LOCAL MEMBER OBJECTIONS AND PETITION

APPLICATION No. **16/02726/MNR** APPLICATION DATE: 14/11/2016

LOCATION: 20 WINDSOR ROAD, RADYR, CARDIFF, CF15 8BQ

PROPOSAL: NEW DWELLING IN THE GROUNDS OF 20 WINDSOR ROAD, TO BE NAMED 20A WINDSOR ROAD. INCLUDE FOR NEW SITE ENTRANCE FOR DWELLING

SCALE 1:200 DRAWING NO. 1604 / S01A
 DATE NOV 16 2015 DRAWN BY VT/DB

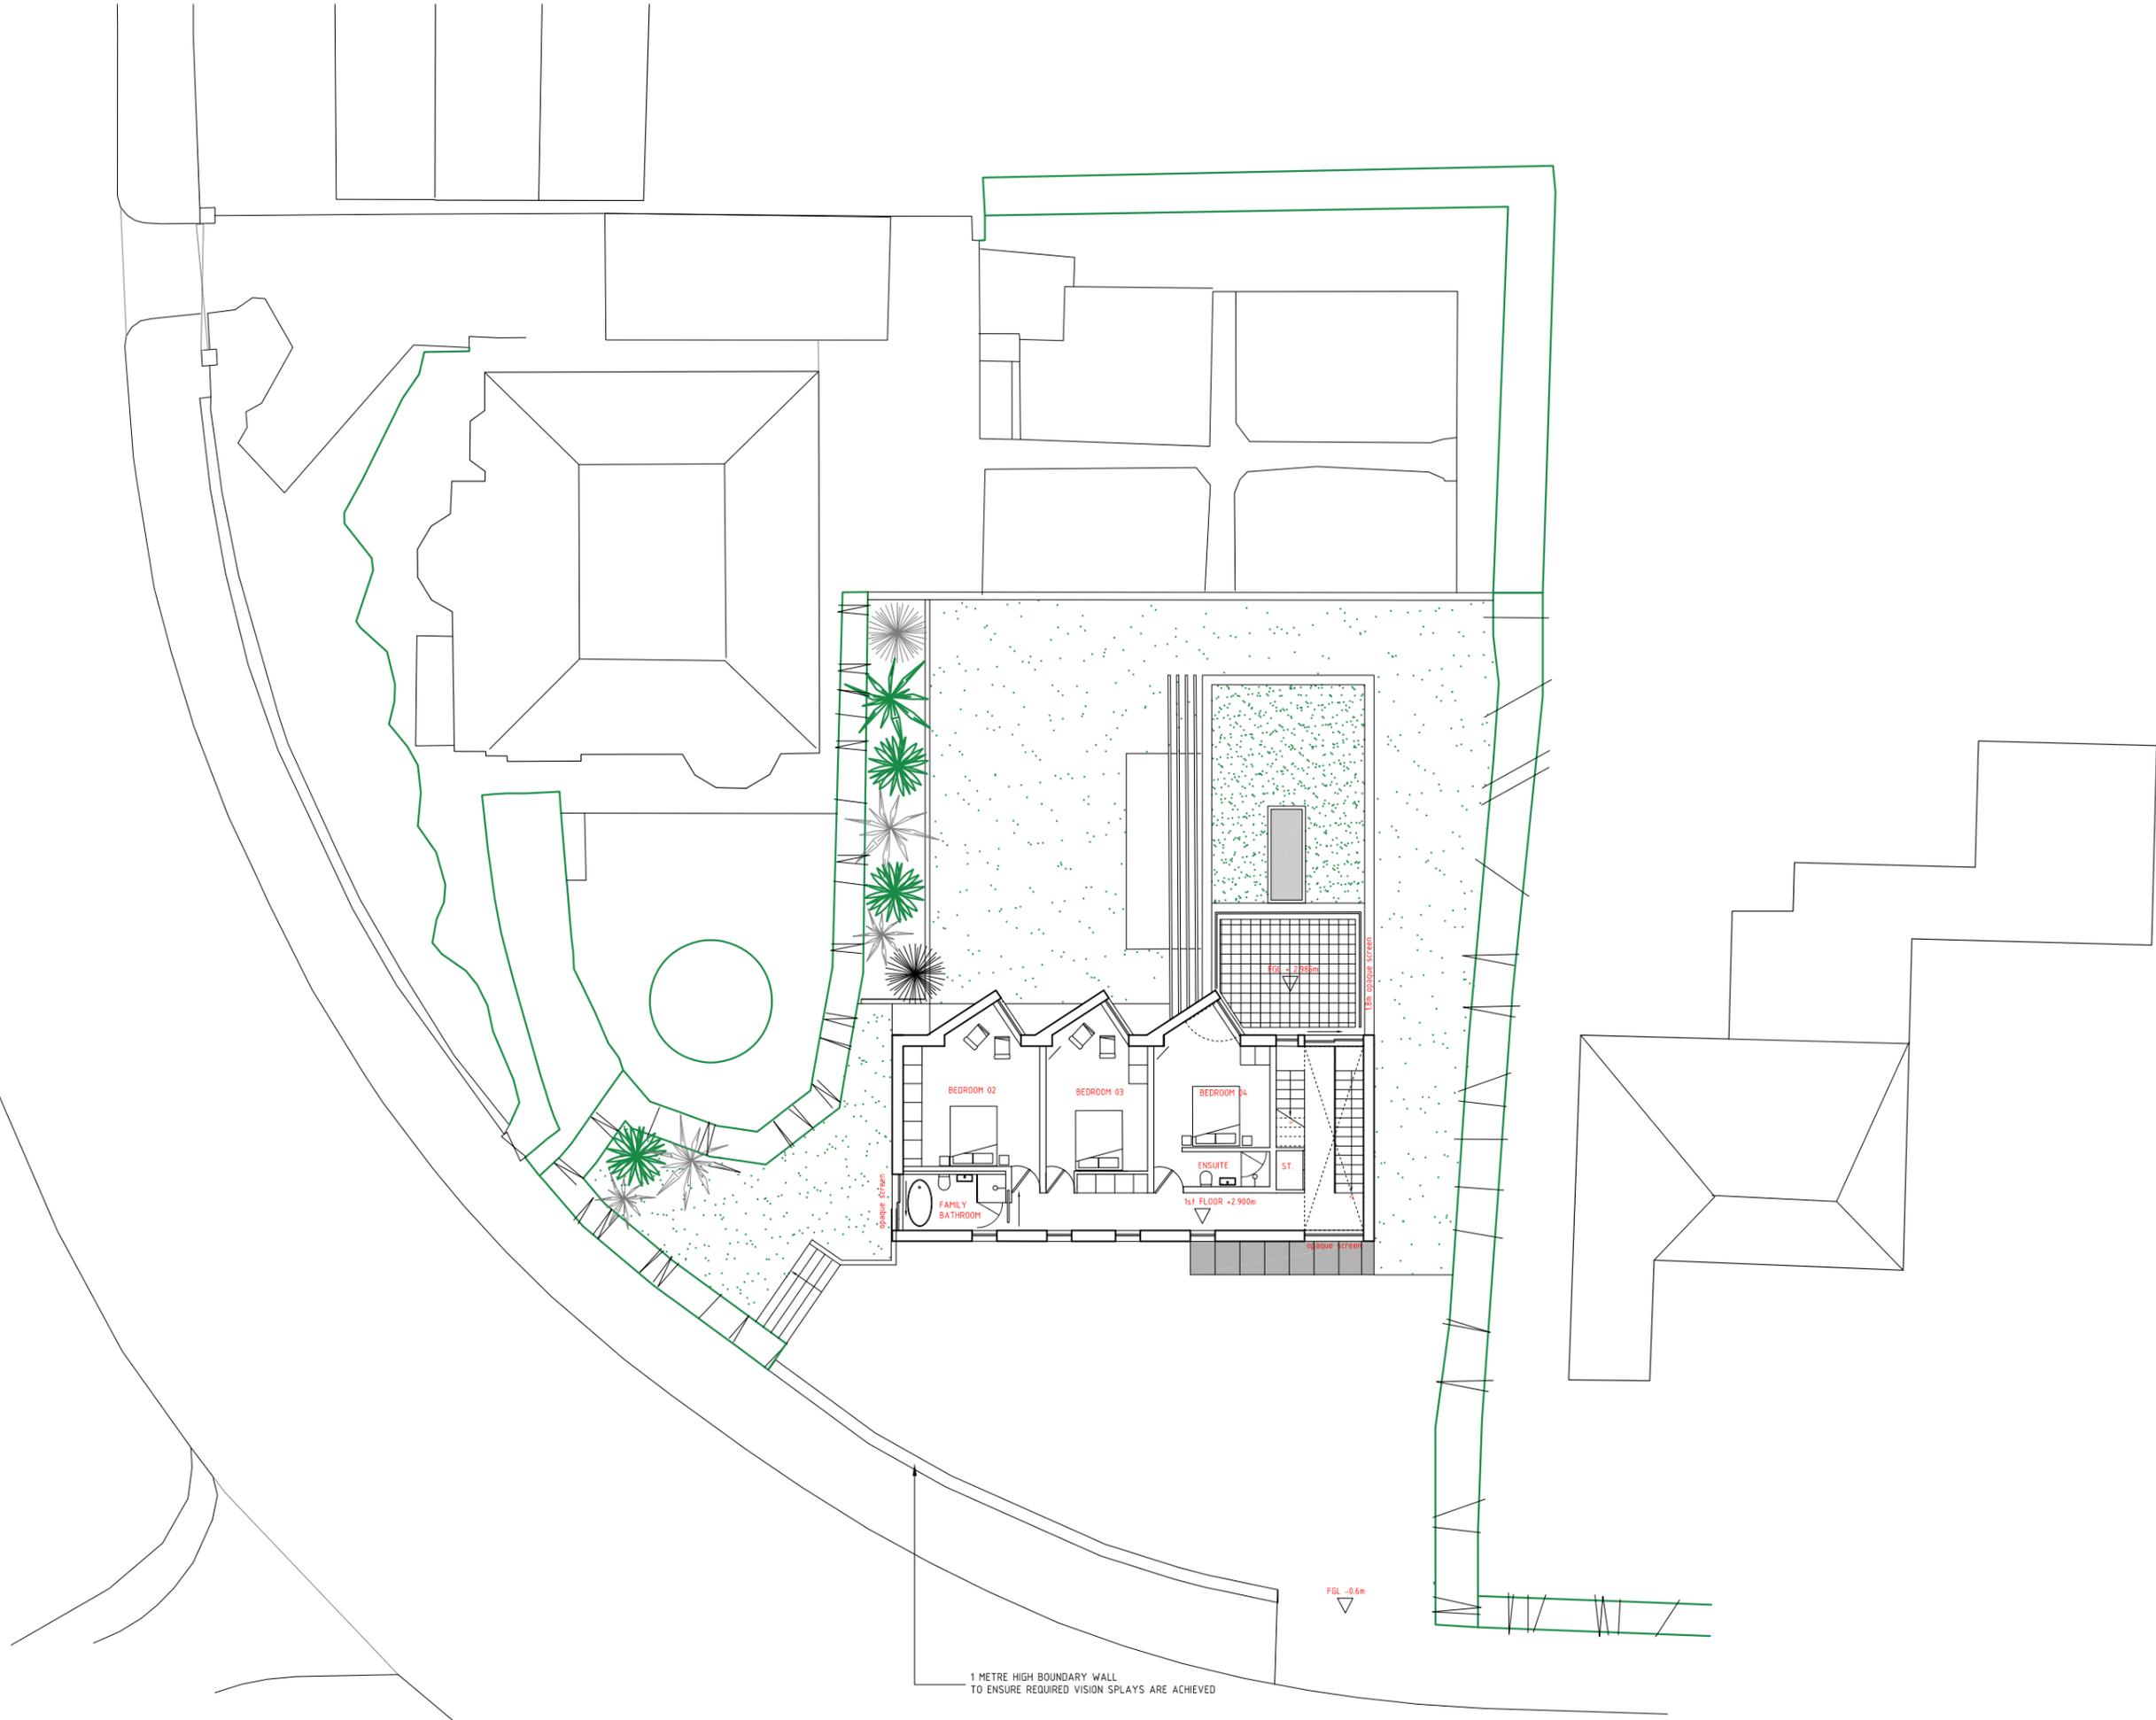
REVISIONS:
 A: RECHECK HEIGHT OF BOUNDARY CONDITION TO ENSURE REQUIRED VISION SPLAYS ARE ACHIEVED

SCALE
1:200 @ A3
DATE
NOV 16
DRAWN
VT/DB
DRAWING NO.
1604 / S101A

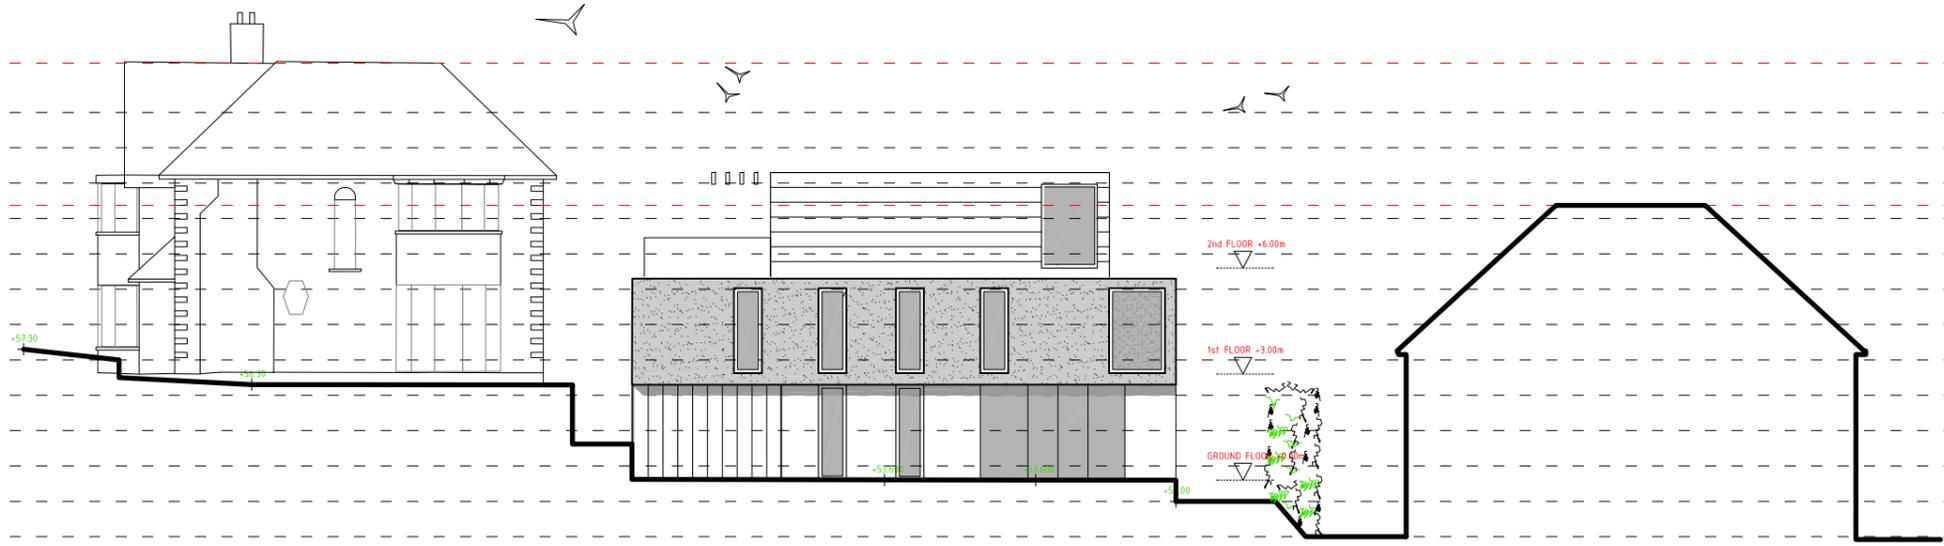
1 METRE HIGH BOUNDARY WALL
TO ENSURE REQUIRED VISION SPLAYS ARE ACHIEVED

REVISIONS
A: REDUCE HEIGHT OF BOUNDARY CONSTRUCTION TO ENSURE REQUIRED VISION SPLAYS ARE ACHIEVED
